Comments to the Hearings Officer
Re: Z0353-19-D
January 12, 2019
Submitted by Tonya Reed

**EXHIBIT 47
Z0353-19-D
Page 1 of 13**

Re: **Washman Carwash – SE 82nd Avenue/SE Lindy Street – Clackamas County, Oregon**
Technical Letter #1 – Response to Appeal of Planning Director Approval

Figure 1 – Original Intended Site Development

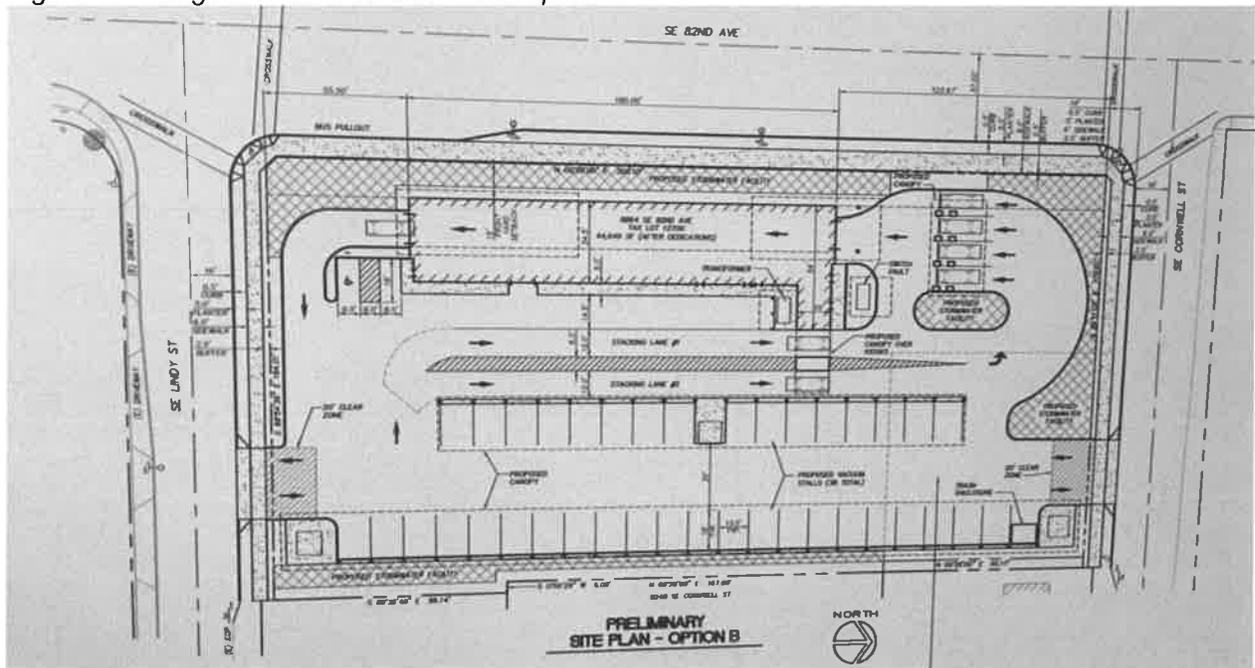
As can be observed, the site plan is rectangular. At the bottom right corner of *Figure 1*, there is a very light, dotted line illustrating the square parcel the Company originally desired to

Figure 2 – Original Proposed Plan Without Rezoning

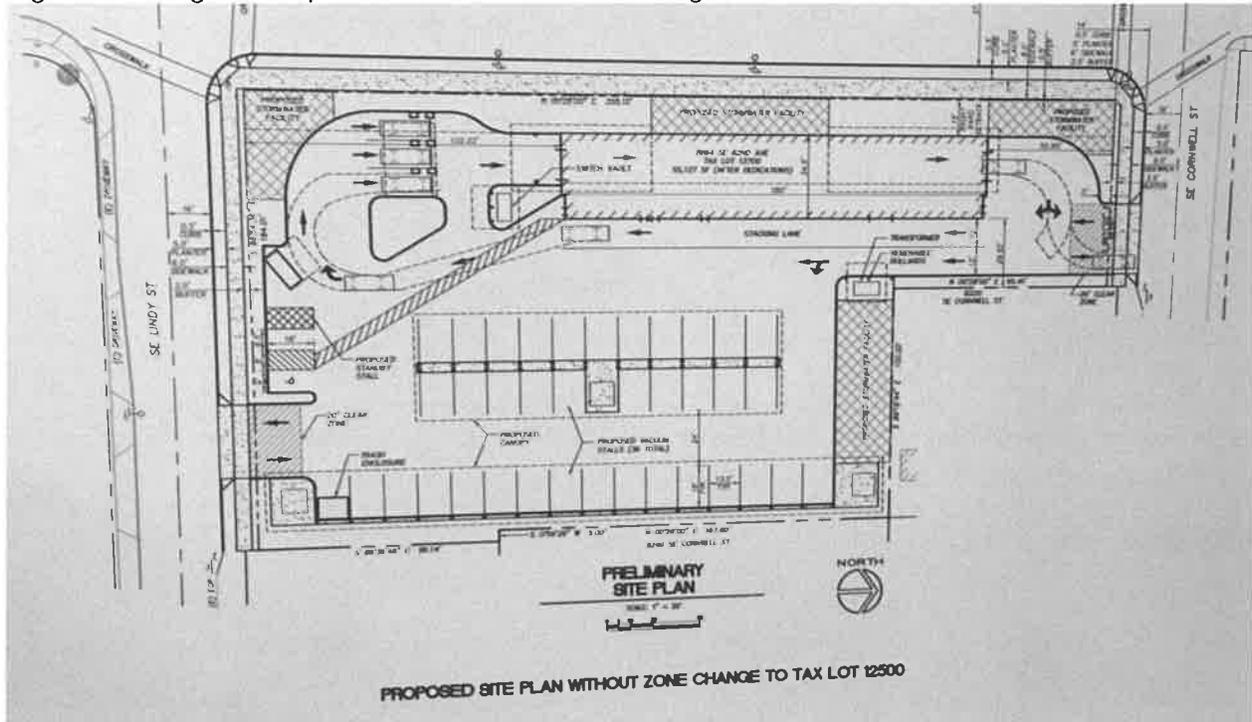
The Company pointed to the top right of this display and lamented that traffic would be highly congested if the County refused to rezone. Washman did not really make mention of the Lindy St. (left side of *Figure 2*) points of entry and exit in public meetings.

Figure 3 – Most Recent Site Design

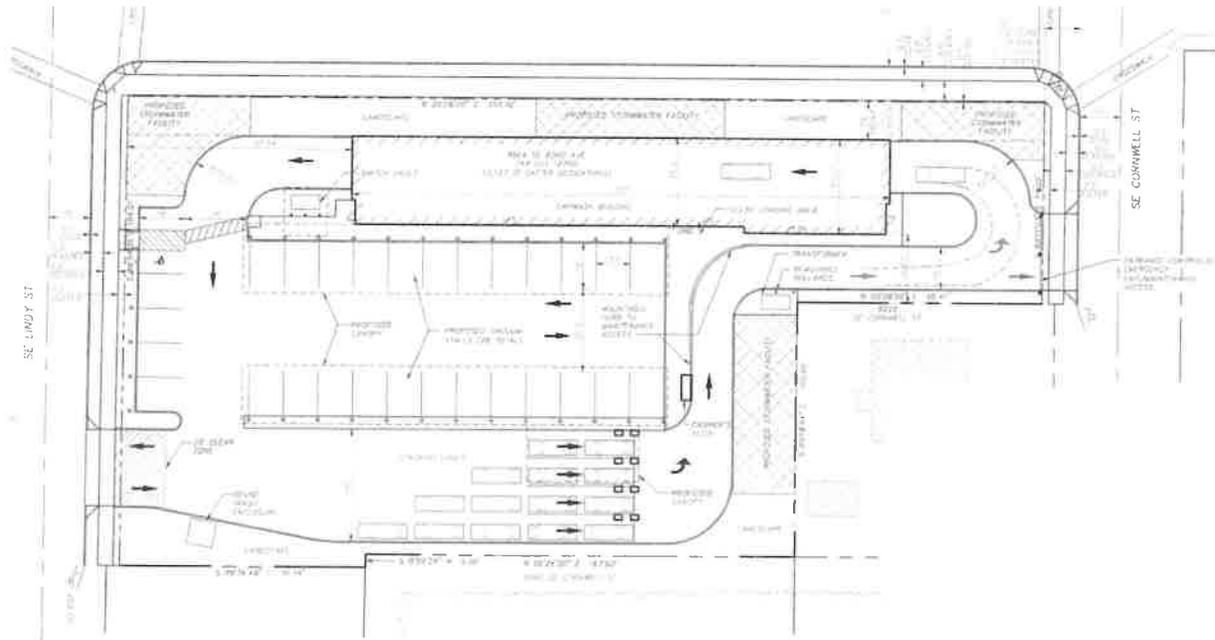
At first glance, the above site design looks very similar to *Figure 2*. However, *Figure 3* contains a material difference in that it lists the Cornwell entrance point (middle right) as an emergency/limited exit. The applicant does not explain what this means. The flow of traffic is also reversed, with primary ingress and egress on Lindy Ave. This is a completely different design than what was originally presented to the Planning Commission and Board.

Figure 4 – Worst Case Traffic Scenario

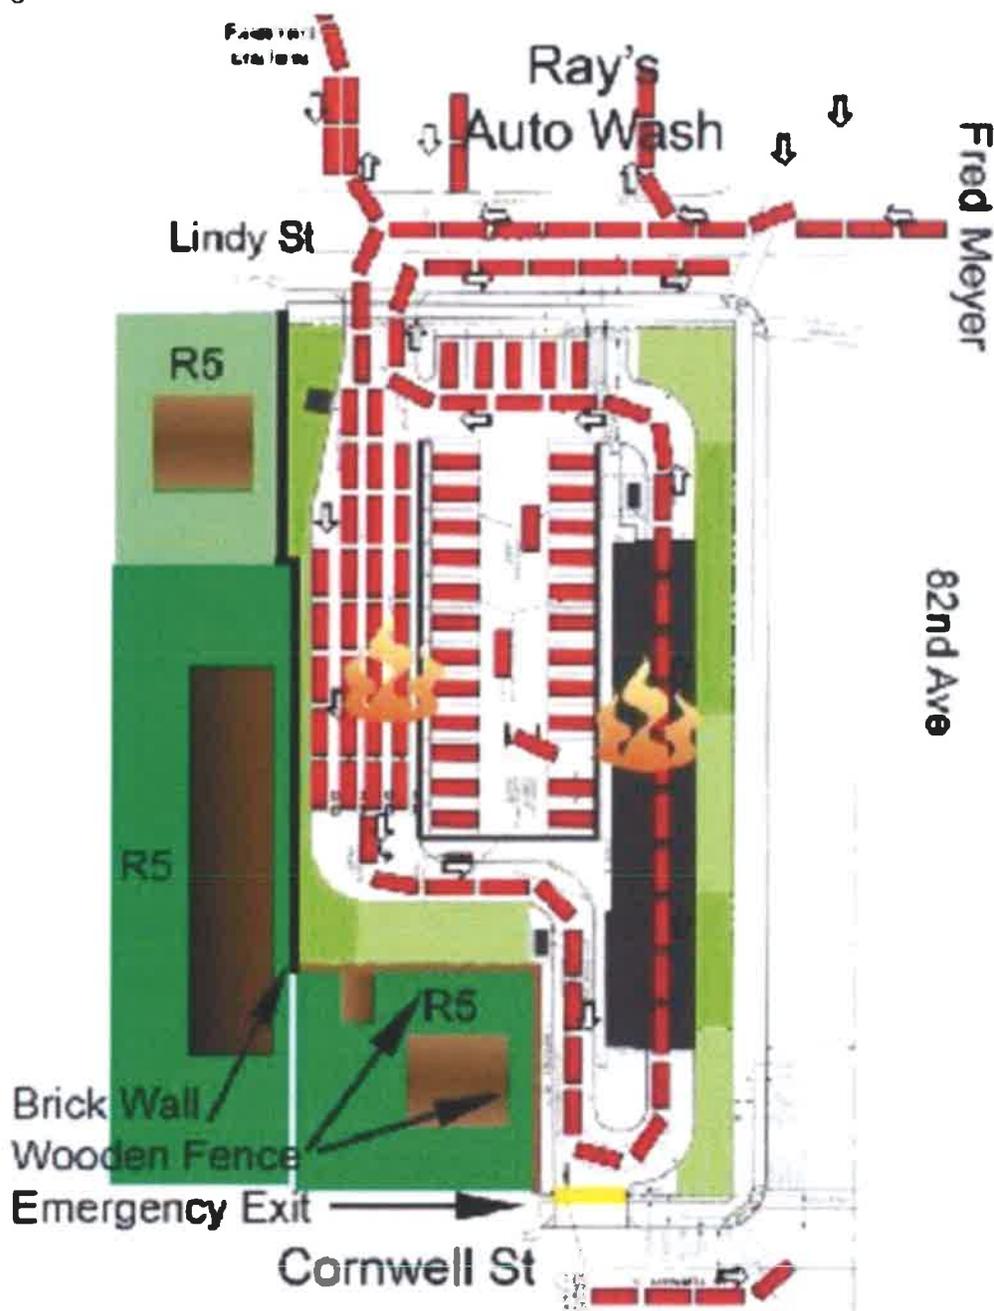
The highest concern is traffic queuing at Lindy and 82nd. It will not take too many cars waiting at the light heading west on Lindy (towards Fred Meyer) before they cause congestion. Getting in and out of Ray's Carwash, getting in and out of Washman's car wash, driving into Lindy, and accessing Black Rock Coffee or Columbia Bank, and importantly, congestion near one of the most highly-accessed TriMet stops on 82nd will all likely be impacted by the car wash.

Alternative Site Plan – submitted to county November 2019

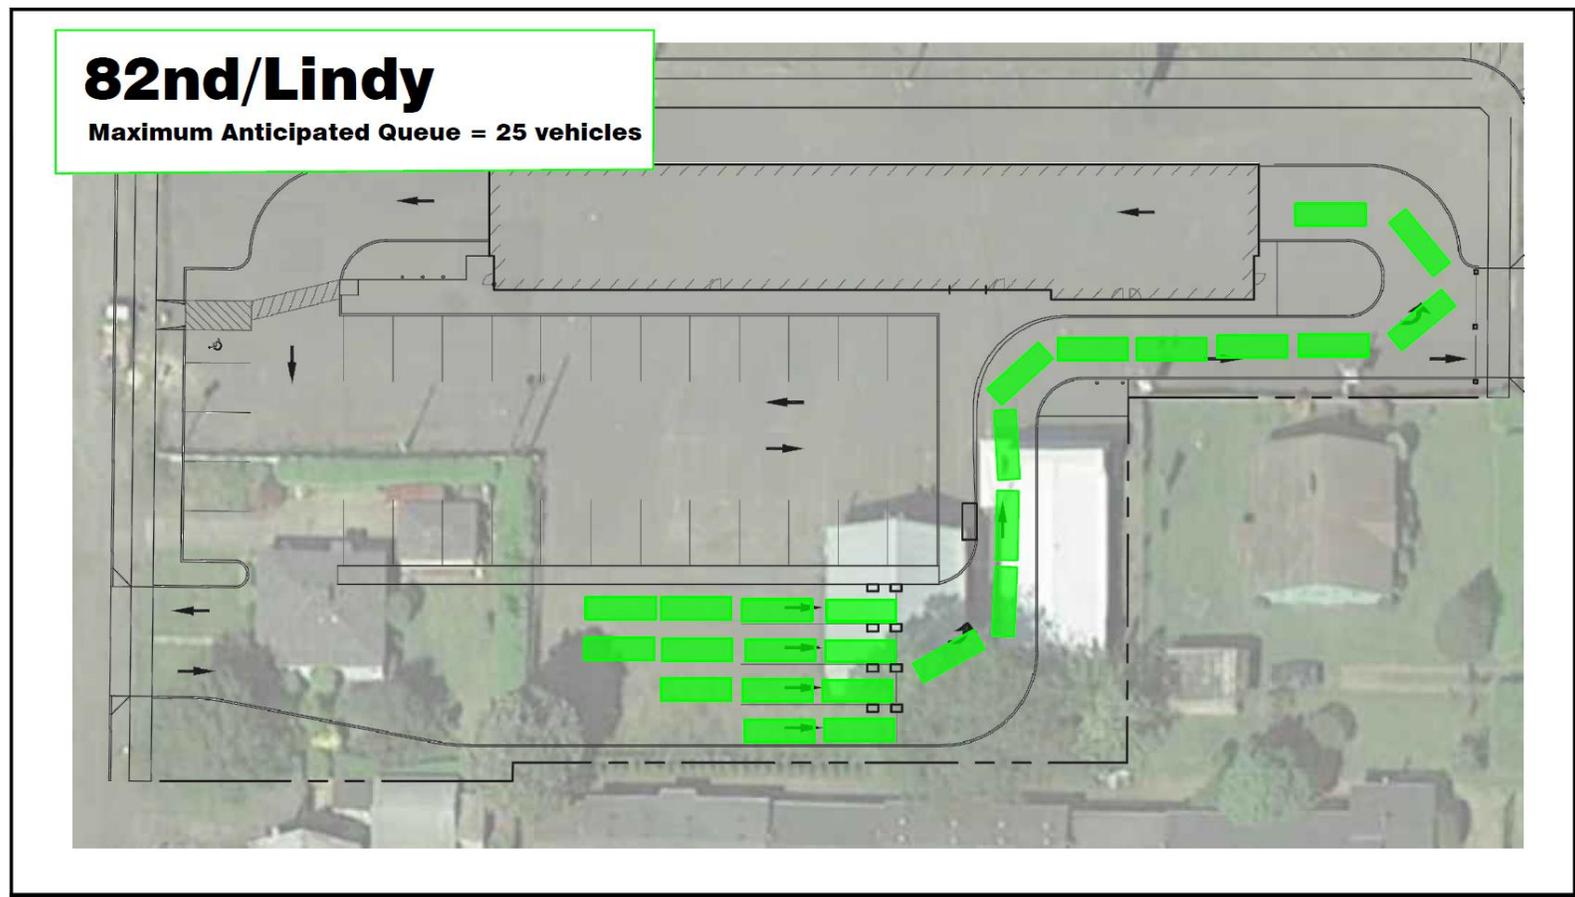
Only differences:

- Wall moves 5 feet closer to west – all setbacks are still met
- One auto pay station is removed
- Loss of one queue lane – queue space goes from 42 to 35 cars
- Still more than adequate queue for vehicles
- No significant operational change results for implementing alternative
- Seek approval of alternative site plan if the disputed 5 feet on the east property line is determined by court in pending litigation to be owned by another

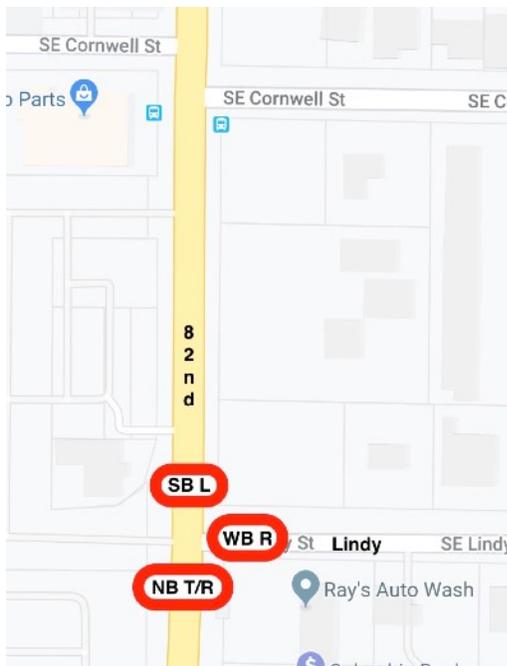
Table 6 from Clemow Traffic Analysis for Washman, page 6, (shown here) the most sizable “2020 Post-Development” increase in queue length will happen in the southbound left lane of 82nd as they wait to enter Lindy to access the car wash. This is the same lane mentioned above and illustrated in the previous photo. The queue length is expected to **double**, further complicating the known reported crash history as customers cross traffic on 82nd when leaving via the north Fred Meyer driveway between Cornwell and Lindy. Below the table is a reference image for the queuing descriptions.

Additionally, the Applicant’s “Queuing Analysis Discussion” “SE 82nd/Lindy St” also on page 6, leaves me questioning two things. The first sentence states, “**Development traffic increases primarily on the east intersection leg** which is compensated by the signal controller shifting a small amount of green time from SE 82nd Avenue to SE Lindy Street.” (Bolded for emphasis.) This is either a misstatement or I am misreading something. Based on Table 6 shown here, I have placed a red outline in the table around the leg with the **primary increase**. The queue “SB L” will **increase 100%** - this is the greatest increase in queuing at 82nd and Lindy - meaning the **SB L is the primary increase**. The WB L/T/R will have the second most increase at 50%. This correction is consequential given the now established reported crashes between Cornwell and Lindy where the flow of 82nd traffic is impacted by these crashes. SB L queuing is the primary increase post-development.
